Preliminary Information

PIT6103 Intermittent Power Windows Inoperative - Side Object Detection Indicators On - LIN Bus 3 and 4 Offline

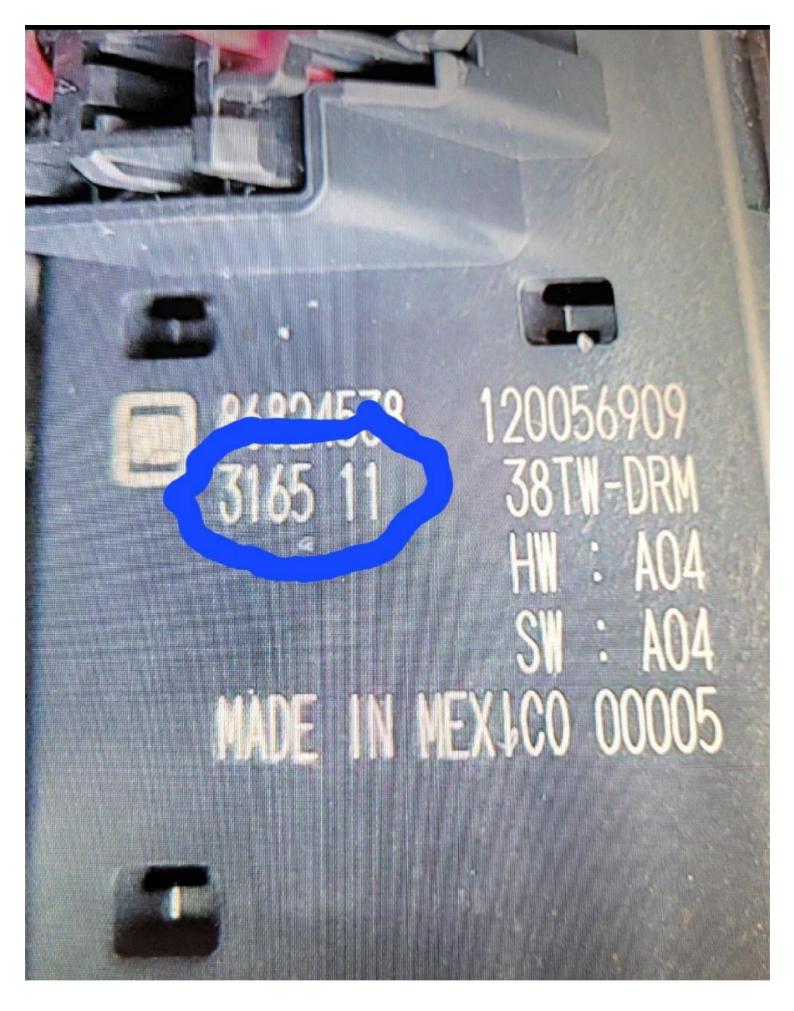
Involved Region or Country:	North America				
Condition:	Power windows inoperative, Service Door Latch message, S.O.D. indicators stay on, door switch				
Condition.	communications codes and U1502/1503 stored. Condition is usually intermittent.				
Cause:	Possible defective diode in one or more of the power window switches.

Inspect the parts label on all 4 window switches. If the date code shown below is between 3156 and 3195 replace the switch. Any one or all 4 can be an issue. Do NOT replace any switches outside these breaks.
